Re: **Site Assessment Workplan Addendum**  
Former Olympic Service Station  
1436 Grant Avenue  
San Lorenzo, California  
Fuel Leak Case No. RO00000373

Conestoga-Rovers & Associates, Inc. (CRA) formerly Cambria Environmental Technology, Inc. (Cambria) prepared this *Site Assessment Workplan Addendum* (Addendum) on behalf of Encinal Properties. The Addendum was requested in the May 7, 2007 Alameda County Environmental Health Department (ACEHD) letter (Attachment A). In addition, this Addendum is based on the May 21, 2007 phone conversation between CRA and ACEHD's Hazardous Materials Specialist, Mr. Steven Plunkett.

Revised Boring Locations

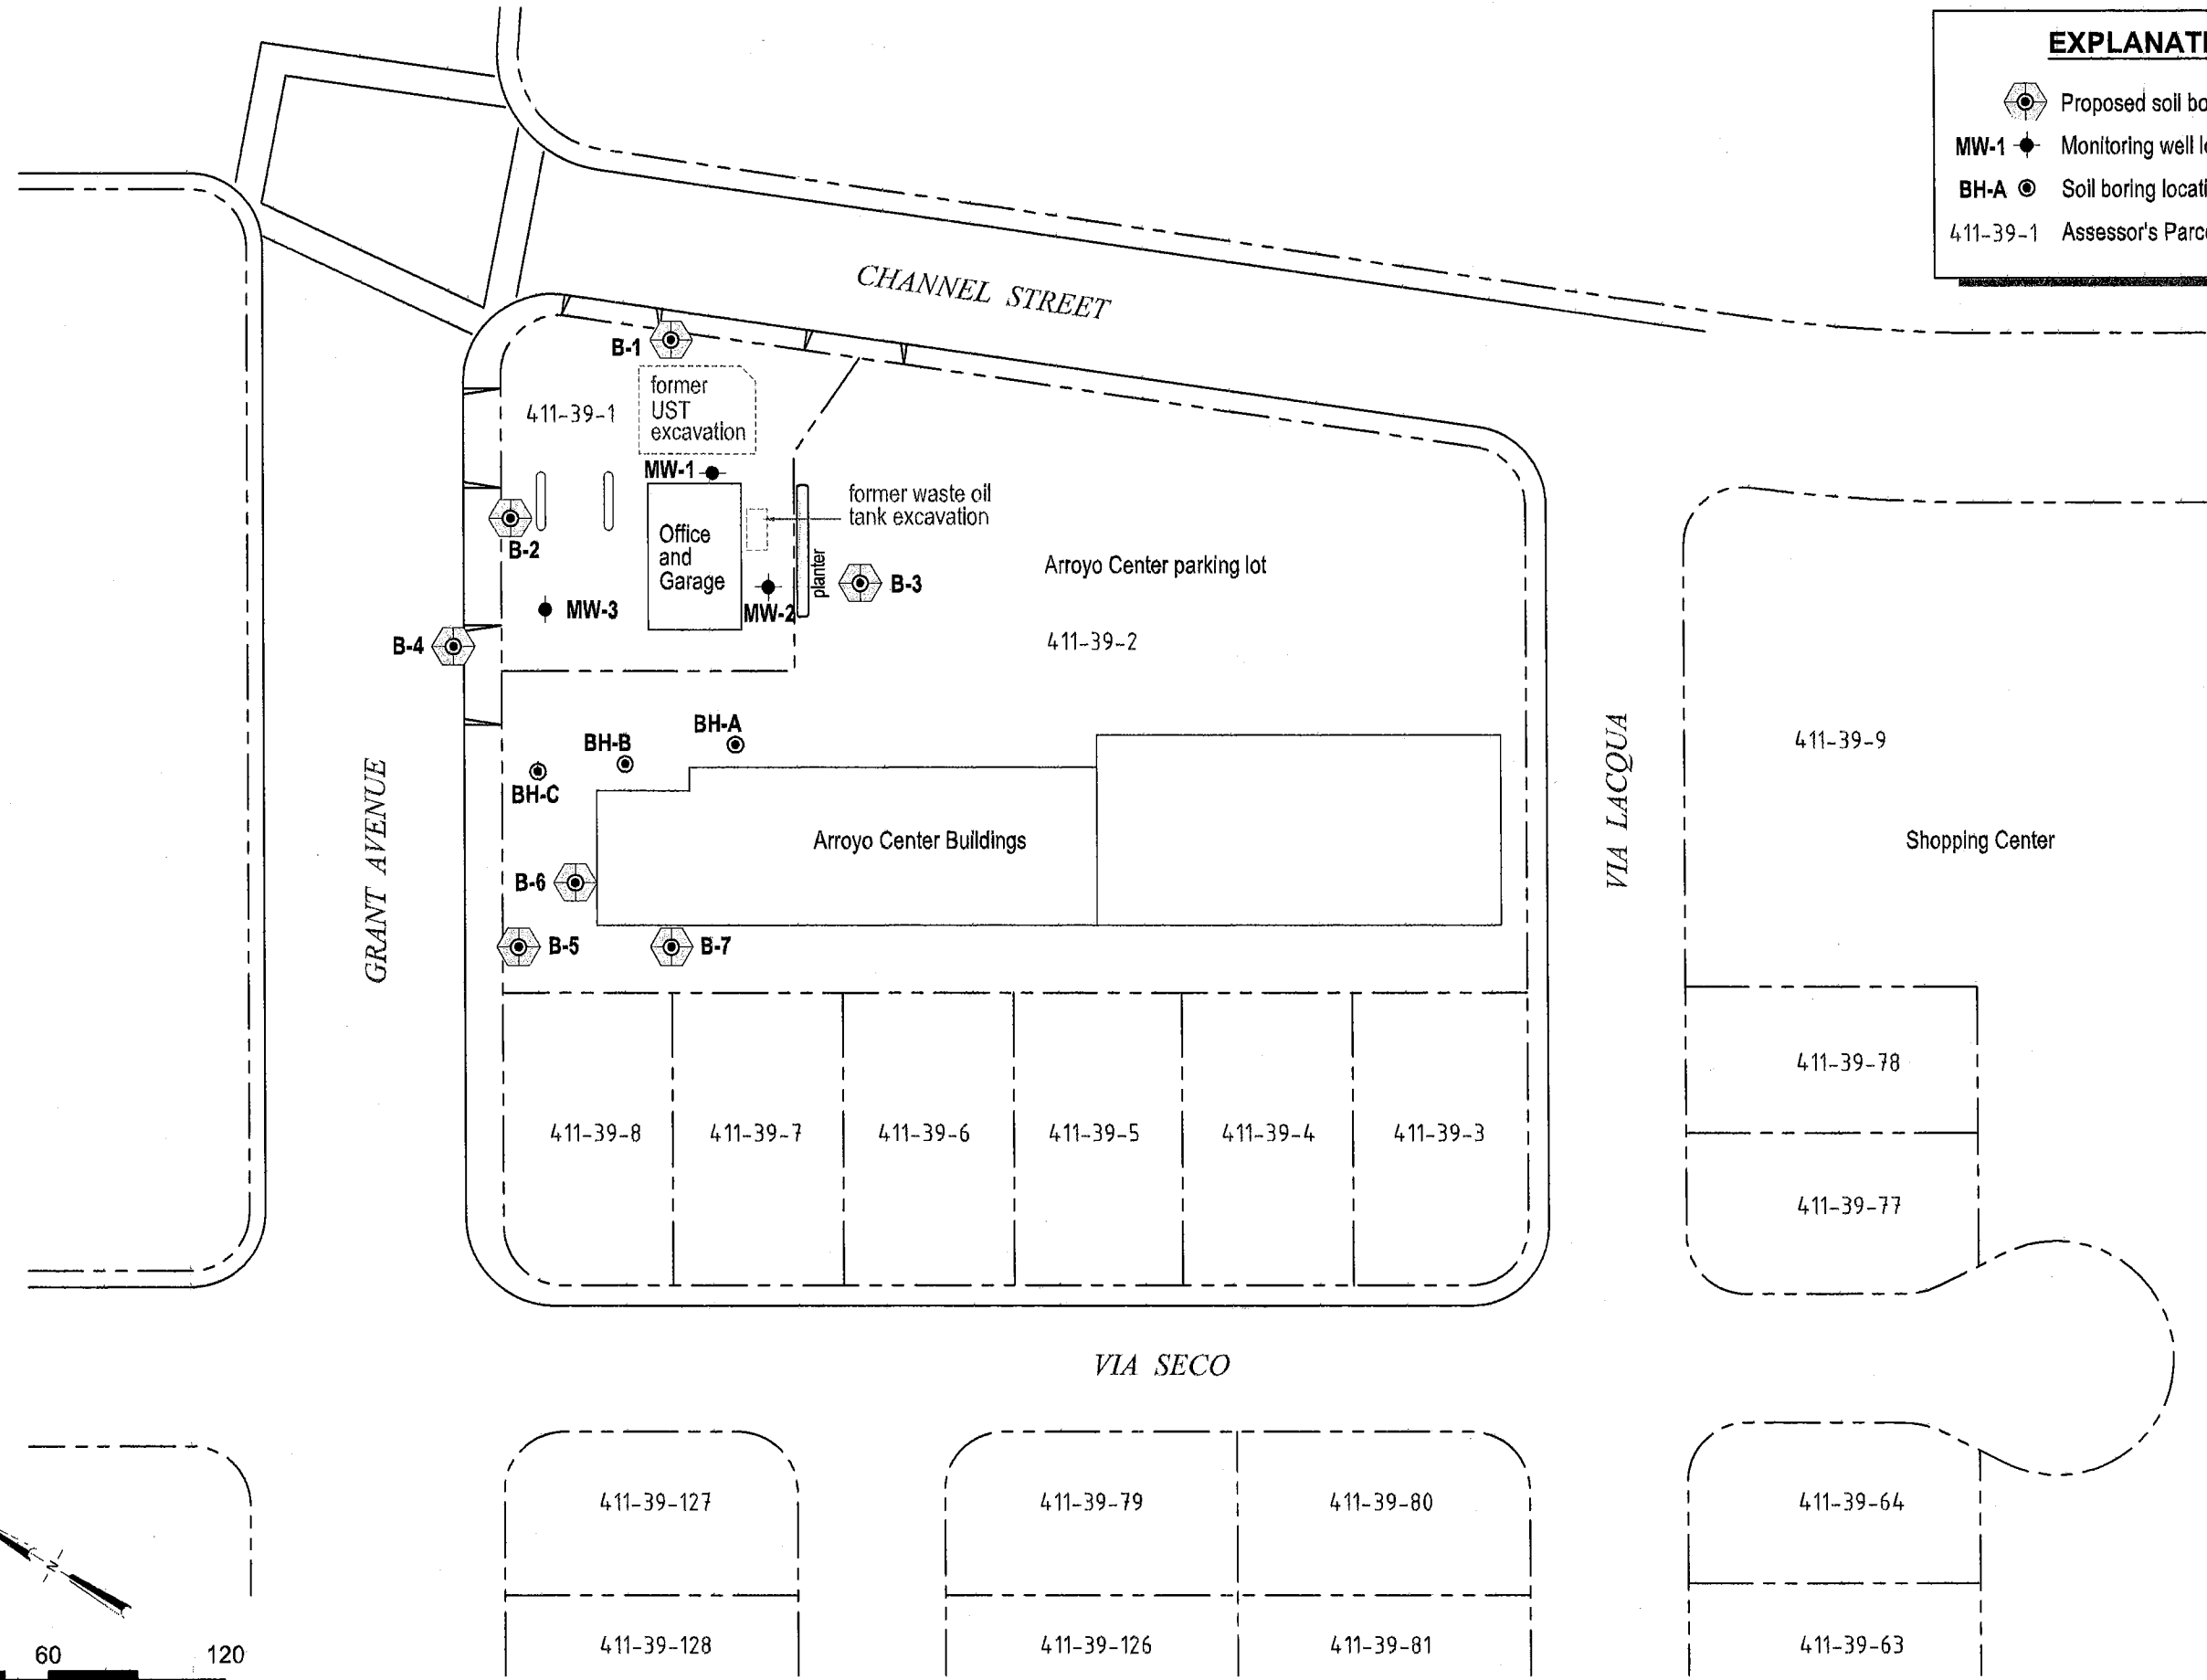
3. **Soil Boring locations.** CRA has proposed the installation of eight onsite and offsite soil borings to further define the extent of soil and groundwater contamination. The soil borings located east of MW-1 and northeast of MW-3 not necessary at this time. Furthermore, the linear separation of two offsite soil borings located between the Arroyo Center Building and parcel # 411-39-8/411-39-7 is approximately 45 feet, which may not adequately constrain the orientation of the petroleum hydrocarbon plume. Therefore, ACEH request a soil boring be installed between these two soil boring adjacent to the Arroyo Center Building. Lastly, the soil boring located near the corner of Grant Avenue and Channel Street should be relocated downgradient of MW-3 near the property boundary in the Grant Avenue right of way. Please update Figure 3 to reflect the location of seven soil borings in the Revised Work Plan requested below.

In the May 7, 2007 letter, the ACEHD proposed revised boring locations. On May 21, 2007 CRA and ACEHD discussed the revised boring locations during a phone conversation. The agreed upon proposed boring locations are presented on Figure 1.
